Re: Agency Response and Well Installation Work Plan Addendum

Shell-branded Service Station 9750 Golf Links Road Oakland, California Incident # 98995744 Cambria Project # 244-0735

RESPONSE TO OCTOBER 9, 2002 LETTER

Proposed Monitoring Well Location Map

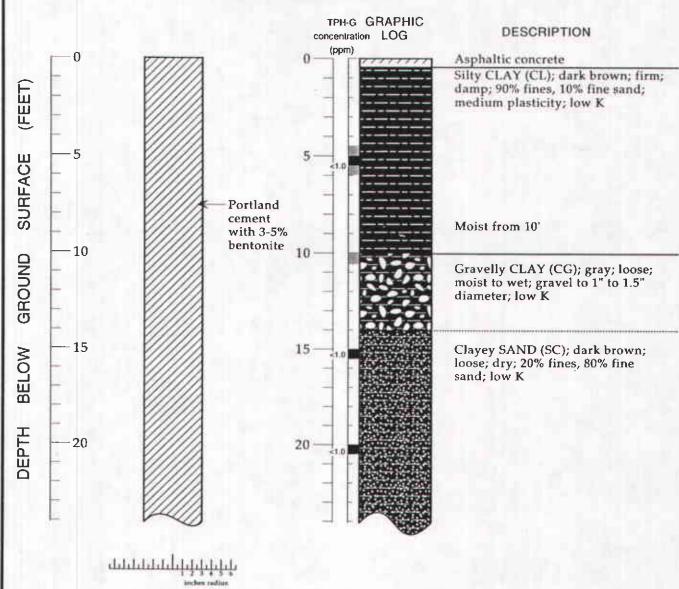
Monitoring Well Locations - We do not concur with one of the locations proposed, south of the former fuel tanks. We feel that this location may miss downgradient flow from the former fuel tanks although we do want a well within 10 feet of the former fuel tanks and another one within 10 feet of the former dispensers in the downgradient direction. Include your proposal to meet these requirements in the revised work plan.

Assumed groundwater flow direction based on topography in the site vicinity is west. The dispenser islands at the site are located immediately west of the USTs. Due to the dangers of drilling between the dispenser islands and the USTs, Cambria does not recommend completing a boring immediately west of the USTs. Cambria instead has amended the location of the proposed well near the USTs from south of the tank pit to northwest of the tank pit (Figure 2). Cambria feels that this location coupled with the additional proposed locations along the western property boundary will adequately assess groundwater conditions downgradient of the USTs at the site. In addition, Cambria has added a fourth proposed monitoring well location downgradient of the dispenser islands at the site (Figure 2).

Boring Log - Soil Boring B-1 - Shell Service Station, WIC#204-5508-2808, 9570 Golf Links Road, Oakland, California

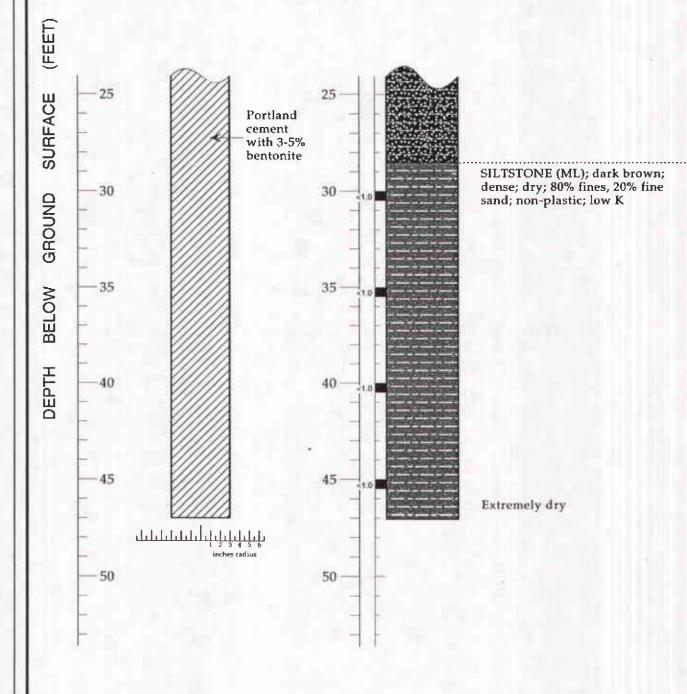
B1 Boring - Missing log. Submit.

The boring log for B-1 is included as Attachment A.
